In re Application of:)	
)	
Shinya KONDOH)	
)	
Serial No.: 09/981,791)	Group Art Unit: 2673
)	
Filed: October 19, 2001)	Examiner: A. Mengistu
)	
For: ANTIFERROELECTRIC LIQUID)	
CRYSTAL LIQUID DISPLAY AND)	
METHOD OF DRIVING THE SAME)

REQUEST FOR APPROVAL OF DRAWING CHANGE

Fig.7

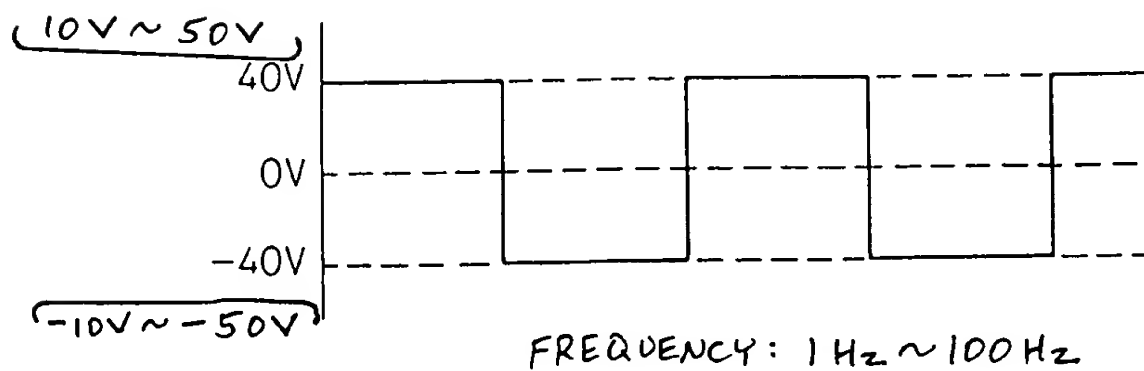
Subject to the approval of the Examiner, it is respectfully requested that Fig. 7 in the above-captioned application be amended to include labels for the frequency range and the maximum/minimum voltage values. The changes are indicated in red on the attached copy of the originally filed drawing sheet.
